**Official Transcript of Proceedings**  
**NUCLEAR REGULATORY COMMISSION**

Title:                   Advisory Committee on Reactor Safeguards  
                              US-APWR Subcommittee Meeting

Date:                    Monday, November 29, 2010

US-APWR SUBCOMMITTEE MEETING

## NRC RAI

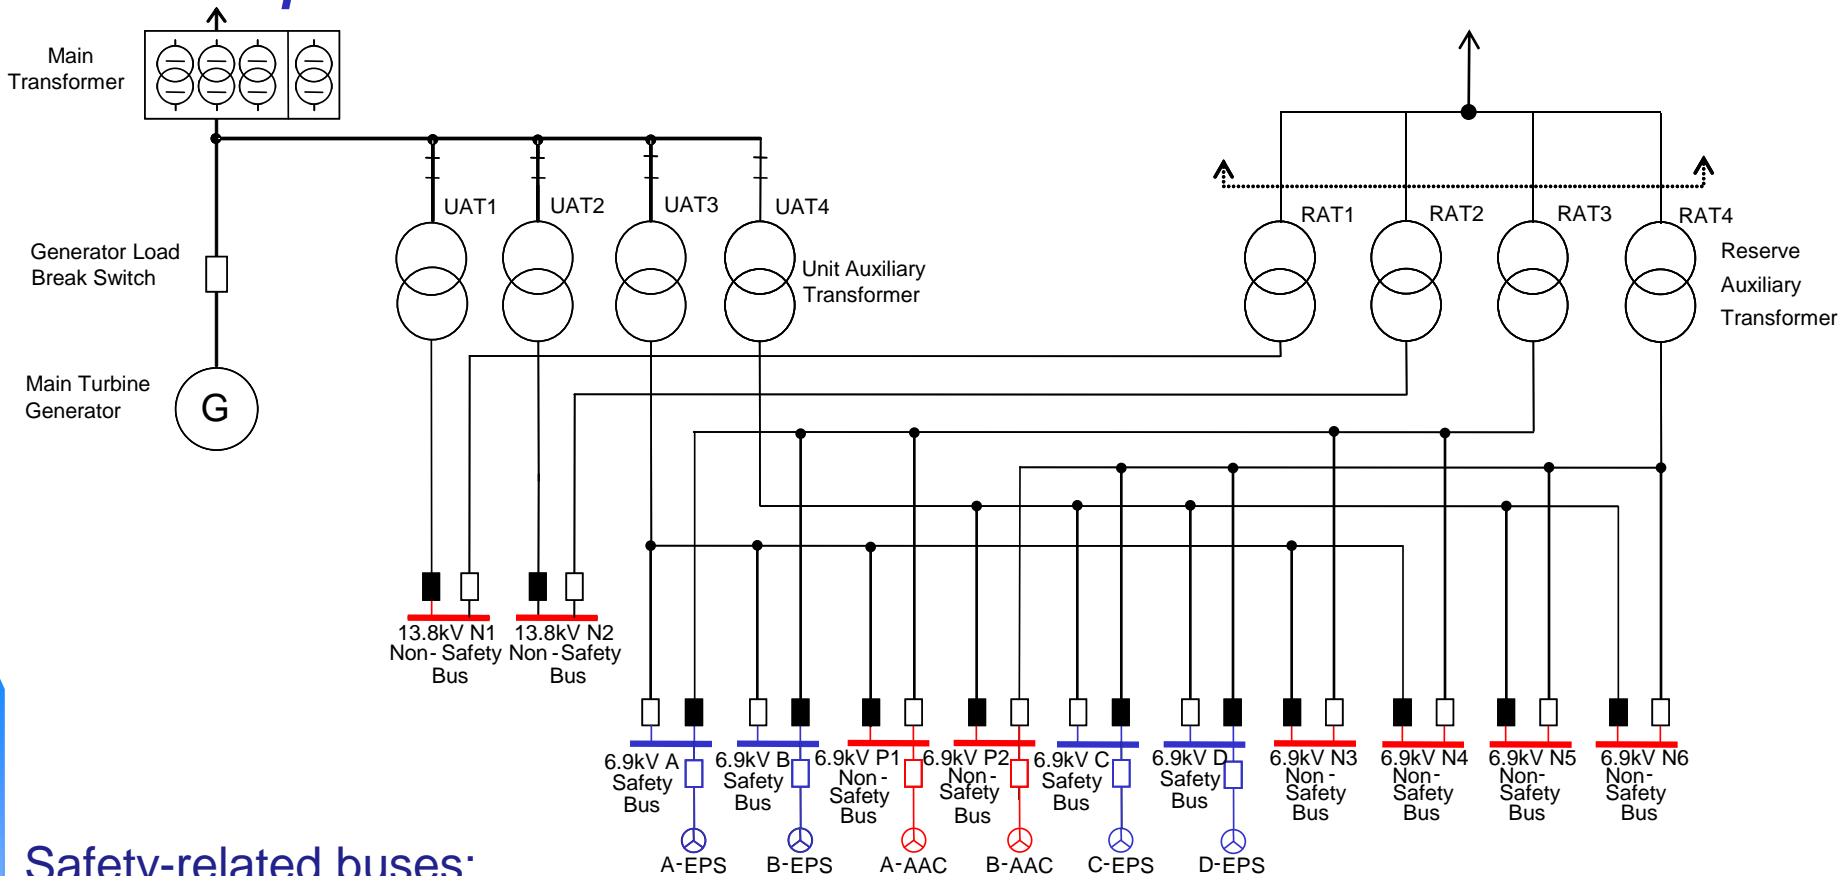
4 The first one we got was really on Section  
5 8.2. It has to do with the redundancy of and the  
6 requirements for the onsite power system. This is  
7 essentially the question regards SECY 91-078, and that  
8 advanced reactor shouldn't have any intervening non-  
9 safety buses between offsite power and the onsite  
10 power system.

- 1) Supply Power To The Onsite Class 1E Power System
  - SECY-91-078\* requirement;
    - ✓ An evolutionary plant design should include at least one offsite circuit to each redundant safety division supplied directly from one of the offsite power sources with no intervening non-safety buses in such a manner that the offsite source can power the safety buses upon a failure of any non-safety bus.

17           Our response was we looked at that and  
18 essentially changed the power source for these two  
19 buses to be normally the unit auxiliary transformers,  
20 and that effectively isolated all the safety buses  
21 over on these two transformers.

### ➤ 2) Redundancy of Onsite Power System

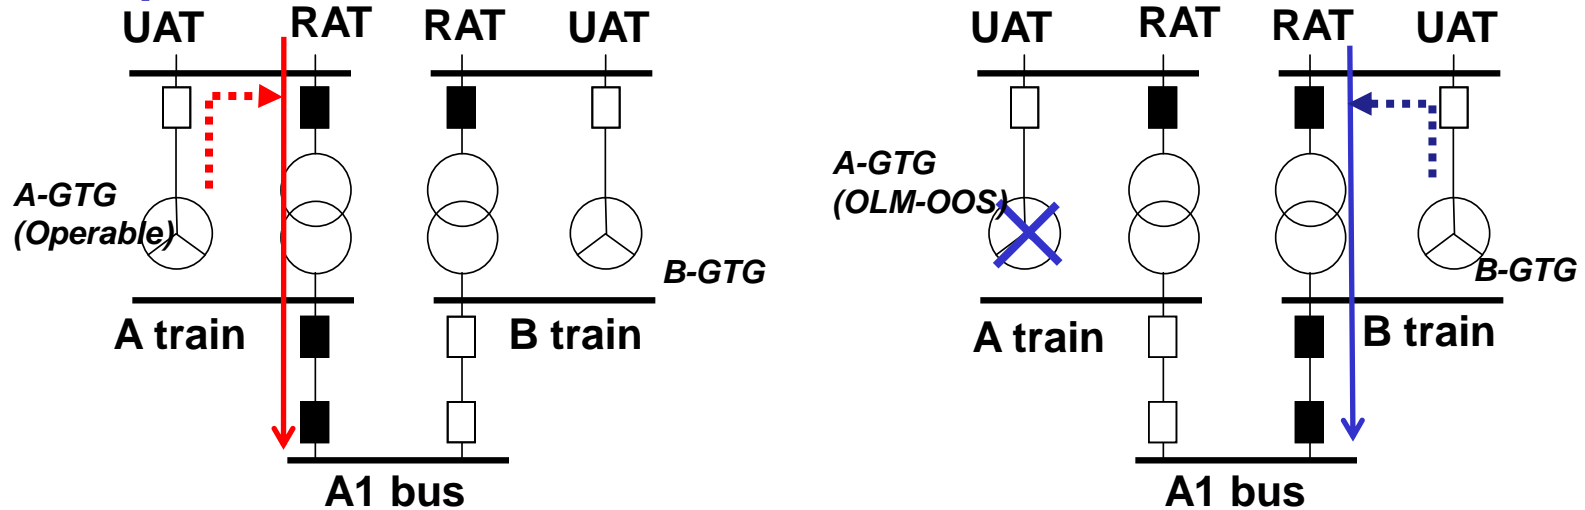
16                  MR. BARNES:     This goes to the redundancy.  
17     That was one of the questions.     Any two of the four  
18 trains is adequate to meet the electrical load.     These  
19 are the actual concerns.

20                  "And with any two of the trains, can you  
21 achieve the emergency power system safety function  
22 with one train out of service?"     It is essentially  
23 goes back to the question you were asking before about  
24 the A and the D buses.

- Any 2 of the 4 trains is adequate to meet electrical load requirements during LOOP, and LOOP & LOCA occurring simultaneously.
- Any two out of four trains can achieve the Emergency Power System's safety function with one train out of service and with a single failure on another train.
